Transmission and Drivetrain: All Technical Service Bulletins Transmission Fluid Leak From Pump Body Replace Bushing

Bulletin No.: 57-71-26B

Subject:
Transmission Fluid Leak from Pump Body (Replace Bushing)

Models:
1995-96 Buick Road master
1995-96 Cadillac Fleetwood
1995-96 Chevrolet Caprice, Camaro, Corvette
1995-96 Pontiac Firebird

Figure 1 - Hydra-Matic 4L60-E Transmission Identification Information

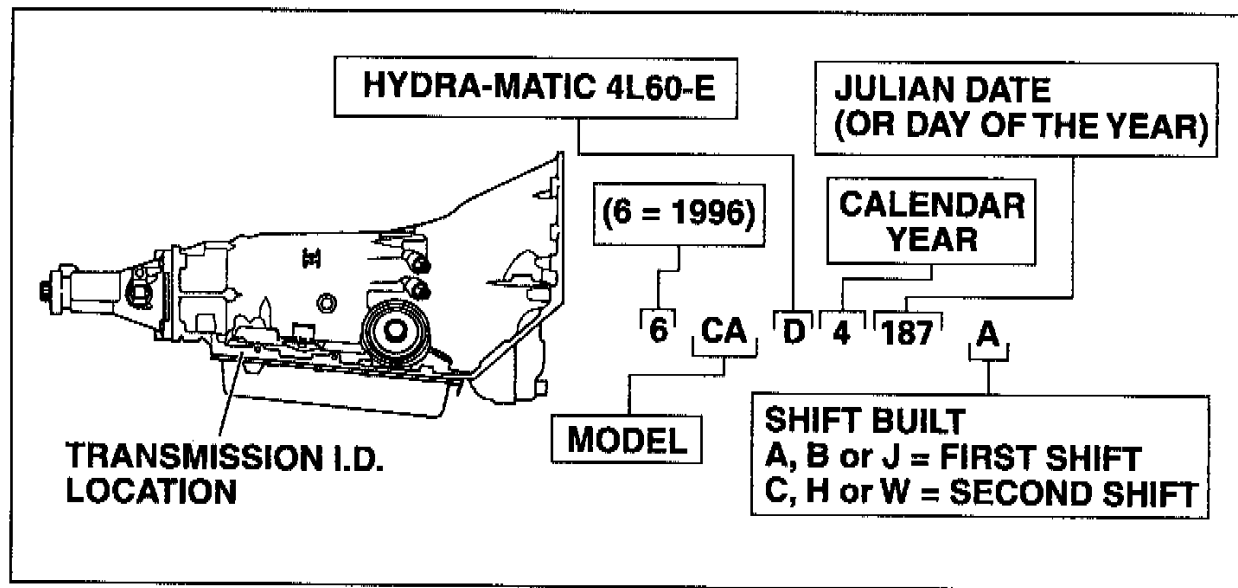
(Figure 1) Some owners may experience a pump fluid leak. Starting September 11, 1995 (Julian Date 254) all units are built using a revised design body bushing.

The pump bushing is spinning or walking out of the body.

Replace the pump body bushing using Kent-Moore tool J 41778.

Figure 2 - Remove Front Helix Retainer

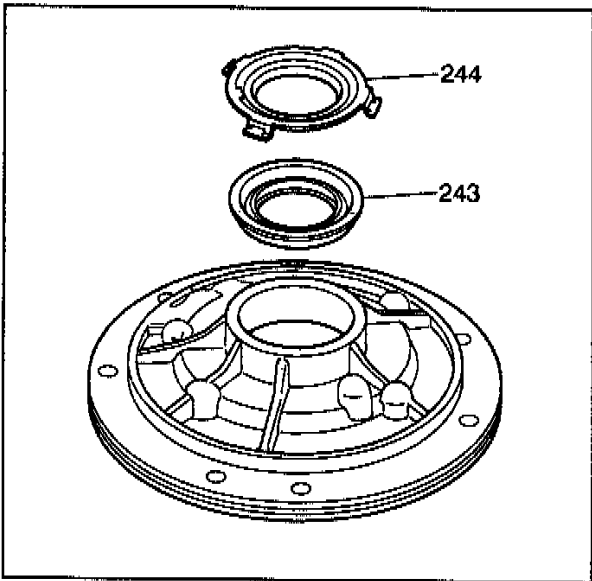
1. Remove the front helix retainer (244).
2. Remove the oil seal assembly (243).
3. Remove the pump body bushing (242) using tool J 41778-1.
4. Install new bushing using J 41778-2 as a positive stop and an Arbor Press with J 41778-1.
